**SUBDIVISION COMMITTEE
METROPOLITAN AREA PLANNING COMMISSION**

**STAFF REPORT
(Preliminary Plat)**

CASE NUMBER: S/D 92-38 HANLEY ADDITION

CASE NUMBER: S/D 92-38 HANLEY ADDITION

STAFF REPORT

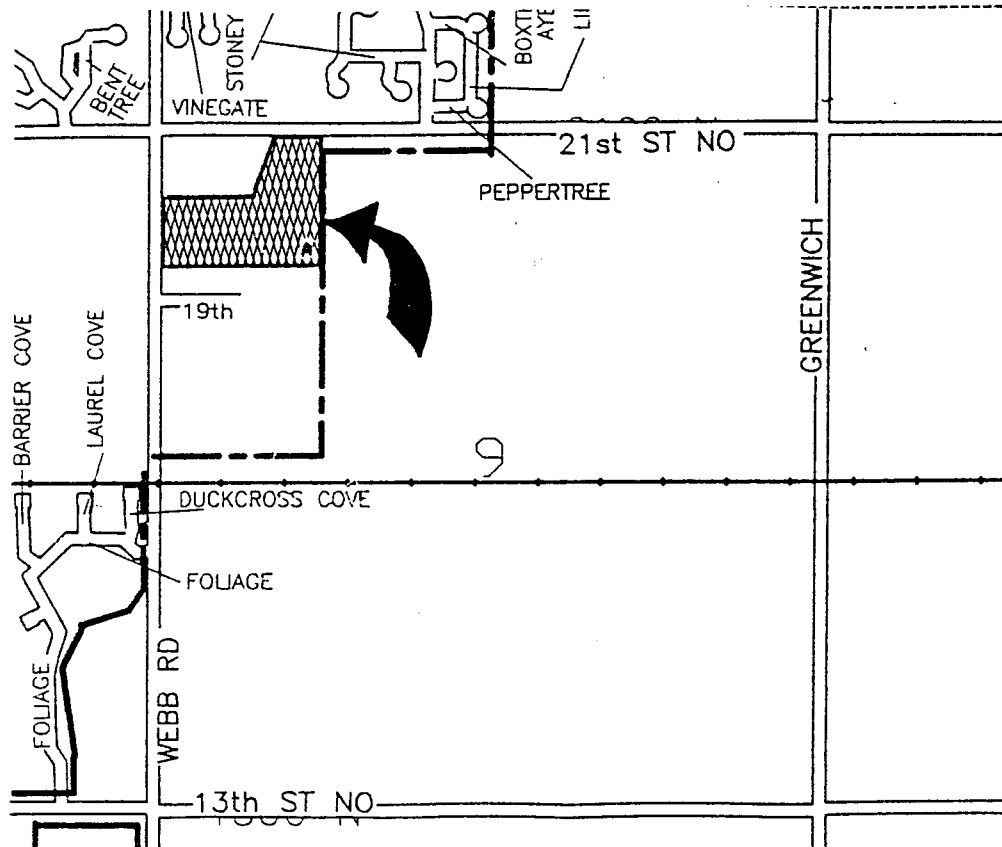
- A. Goebel Street (should be Goebel Circle) is being platted to provide access for Lots 3 and 4. This access can physically be provided only if the applicant is able to obtain an off-site street dedication to connect this segment of street with 19th Street which has been dedicated for a distance of approximately 800 feet east of Webb Road. The off-site dedication, and paving guarantee, will be requirements of final plat approval, along with the guarantee for paving Goebel Circle within this plat. If this off-site dedication and guarantee are not obtained, a road will be required within the 64-foot east-west access easement shown on Lot 2, including a bridge over the drainage within Reserve A.

- B. Sixty feet of half-street right-of-way is required for both 21st and Webb adjacent to this plat. A major entrance will be required into Lot 2 and into Lot 5. Accel/decel lanes to serve these entrances and left-turn lanes will also be required. The applicant shall guarantee these improvements.

- G. As indicated by the Subdivision Regulations, property being platted for office uses shall indicate a 35-foot building setback to arterial streets. Lot 2 shall therefore indicate a 35-foot building setback to Webb Road. (7-206[D]).

- H. The access control to Webb Road on Lot 2 and Reserve A shall be revised to show complete

access control except for the north 64 feet which coincides with an access easement.

STAFF REPORT
(Final Plat, Preliminary Plat Approved 9/3/92)

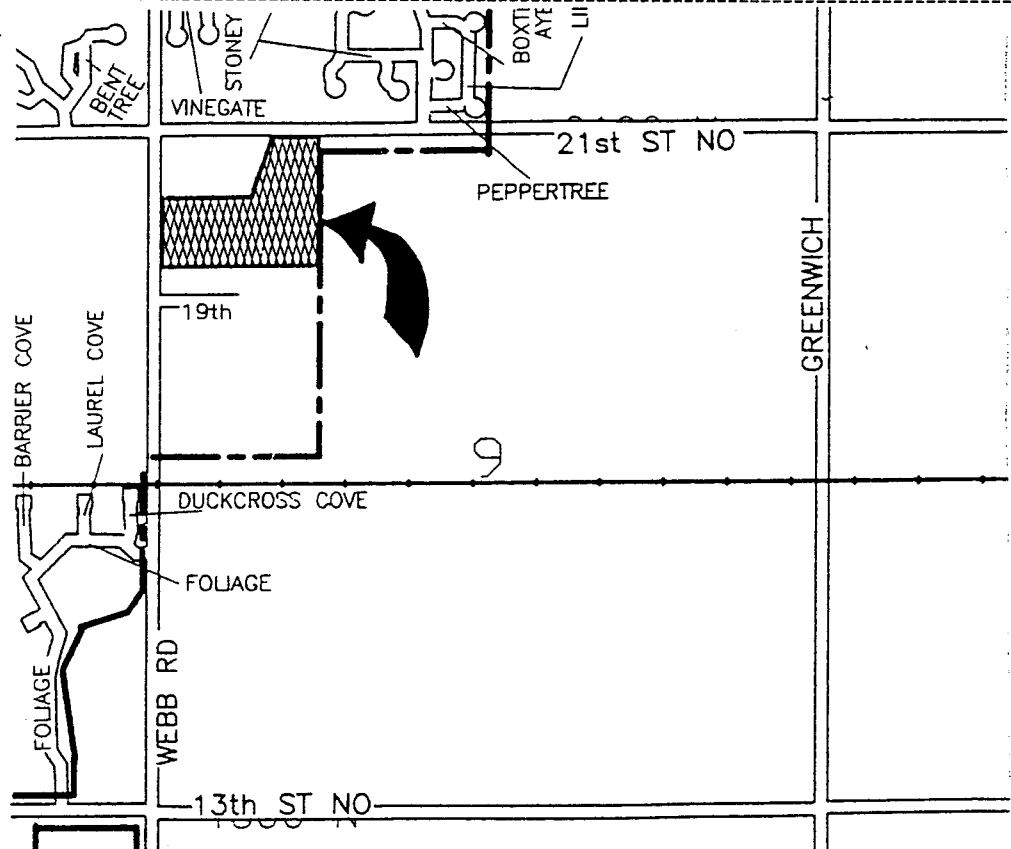
- E. If improvements are guaranteed by petition, a notarized certificate listing the petitions shall be submitted to the Planning Department for recording.
- F. Rather than platting a "Reserve" for floodway purposes, as shown on the preliminary plat, this plat is now indicating drainage easements. City Engineering needs to indicate if drainage easements are acceptable rather than a Reserve. Also, Engineering needs to indicate if the

deletion of the reference to a floodway is appropriate for this site. FEMA floodway maps do not appear to indicate a floodway in this area. If no floodway is involved, the word "floodway" on the face of the plat noted as "limits of floodway" should be changed to drainage easement.

Further, this plat is indicating that various portions of the drainage easement(s) and a sanitary sewer easement are off-site. These areas have not been platted and these easements cannot, being off-site, be granted by this plat. As necessary separate instruments shall be submitted for recording with this plat. Copies shall be submitted to City Engineering for review and approval.

- J. As indicated by the Subdivision Regulations property being platted for office uses shall indicate a 35-foot building setback to arterial roads. Lot 2 shall therefore indicate a 35-foot building setback to Webb Road.

- K. On the final plat tracing, it shall be more clearly indicated that the drainage easement to the north and east of Lot 2 is part of Lot 1 and is not within the perimeter of Lot 2.

STAFF REPORT
(Final Plat, Revised Preliminary Approved 9/29/94,
Final Plat Approved 6/23/94, Preliminary Plat Approved 9/3/92)

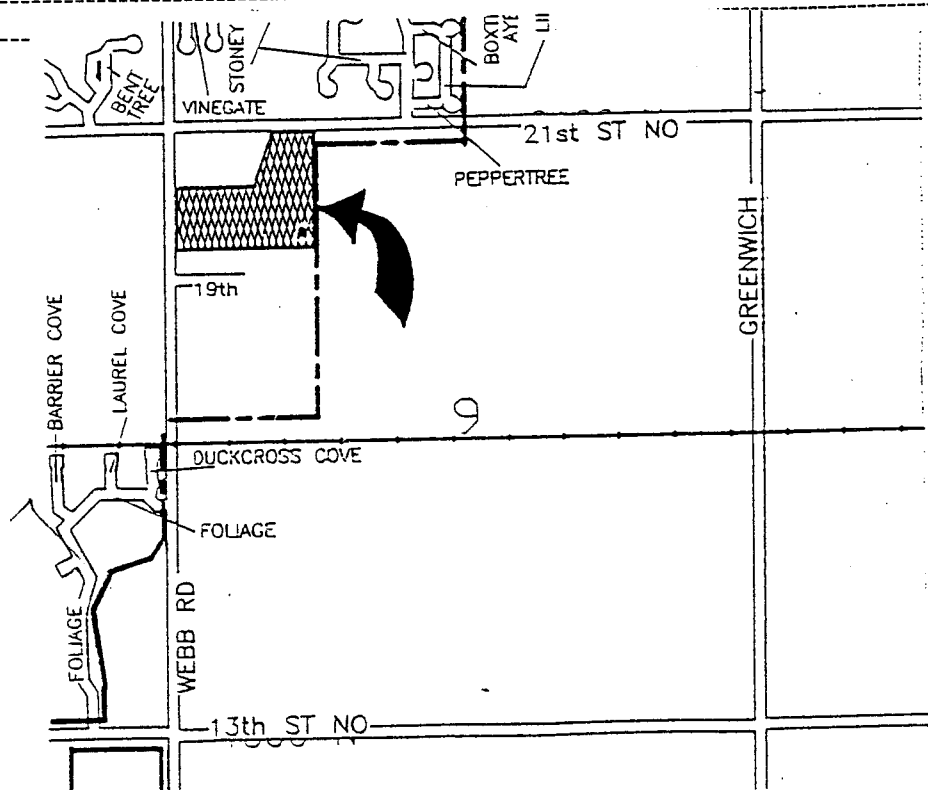
- A. As was indicated during review of the preliminary plat, while Goebel Street (should be Goebel Circle) is being platted to provide access for Lots 3 and 4, this access can physically be provided only if the applicant is able to obtain an off-site street dedication to connect this segment of street with 19th Street which has been dedicated for a distance of approximately 800 feet east of Webb Road. The applicant shall guarantee the paving of Goebel Circle as platted in this addition and shall also EITHER obtain the dedication of and guarantee the paving of the off-site street segment connecting Goebel Circle with 19th Street OR guarantee the construction of a public road within the 64-foot-wide east-west access easement shown on Lot 2, including a bridge over the drainage within Reserve A.

If access cannot be provided by Goebel (cannot obtain off-site right-of-way), the final plat tracing shall delete this street, realign Lots 3 & 4 to include the right-of-way now being shown, and provide access by the above indicated alternative method.

In regard to the alternative means of access as noted in Section 7-208(B) of the Subdivision Regulations "When the subdivider desires to access lots by way of a private street, the private street system shall be platted as a reserve. The private street reserve shall also be platted as a public utility and drainage easement."

That is, a Reserve B shall be indicated on the final plat with the above noted purposes. The Reserve and guarantees for the street shall also provide for a public standard turnaround or cul-de-sac for the termination of the street adjacent to Lots 3 & 4.

- G. As indicated by the Subdivision Regulations, property being platted for office uses shall indicate a 35-foot building setback to arterial streets. Lot 1 shall therefore indicate a 35-foot building setback to Webb Road. (7-206[D]). Further, if Goebel is platted, 25-foot building setbacks shall also be indicated to this street.

- H. Both the face of the plat and the plattor's text shall more clearly indicate the access controls finally established to Webb from Lot 2; eg., if Goebel is platted, then 1-opening in the area north of Reserve A with complete access from Reserve A; if a Reserve B is platted, one opening in the area of reserve B and complete access control to the south; and so forth.

- J. Although no uses listed for Reserve A would be in conflict with utilities, it is unclear if this Reserve is to be a blanket utility easement or since easements are shown, if the utilities are to be confined to such easements. If utilities are to be confined to easements within this Reserve, the plattor's text should be amended to indicate this.
